# SERVICE BULLETIN

BULLETIN NUMBER: 21-0001-NL-GR

SUBJECT: NL-GR SERIES DIESEL UPDATES

PRODUCT LINE: NL-GR SERIES

STEP 1:

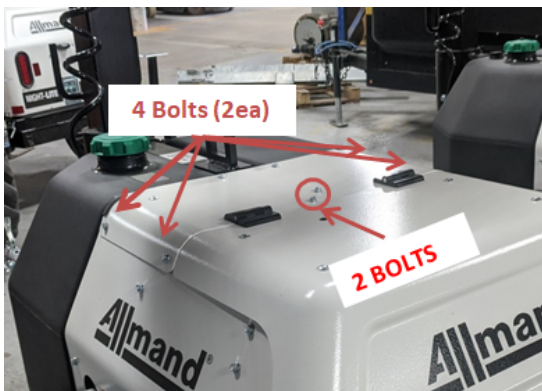
**Item 1:** An additional clamp is needed between the DOC filter and the exhaust.

REMOVE 6 BOLTS FROM TOP COVER AS  
SHOWN. RETAIN BOLTS FOR REINSTALL.  
REMOVE TOP COVER

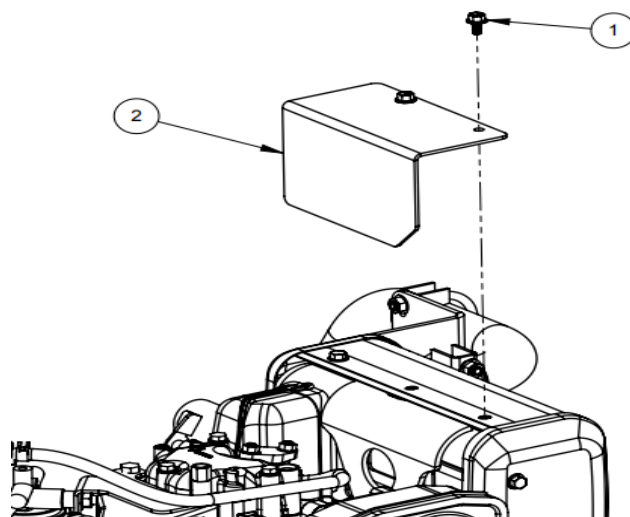
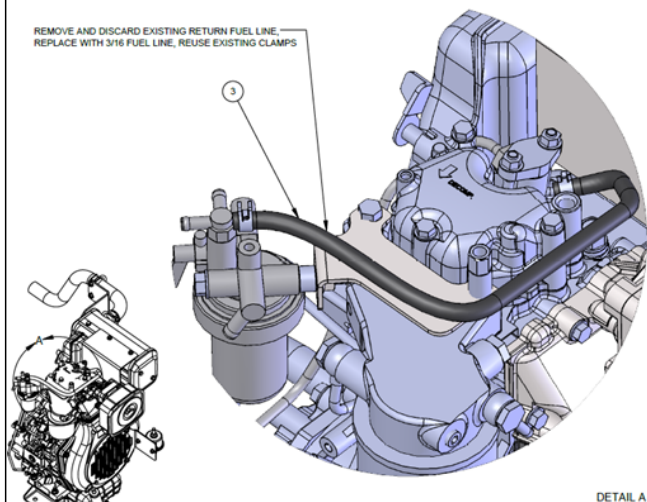
**Item 2:** A heat shield is needed near the exhaust to protect heat sources.

**Item 3:** Replace existing supplier provided fuel line with 3/16" fuel line.

**STEP 1:** REMOVE EXISTING FUEL LINE AND EXISTING BOLTS FROM COVER ON DOC.

**STEP 2:** REINSTALL NEW FUEL LINE AND HEAT SHIELD REPLACEMENT USING DRAWING 120274

**STEP 3:** REPLACE TOP COVER USING THE 6 BOLTS FROM ITEM 1 STEP 1.
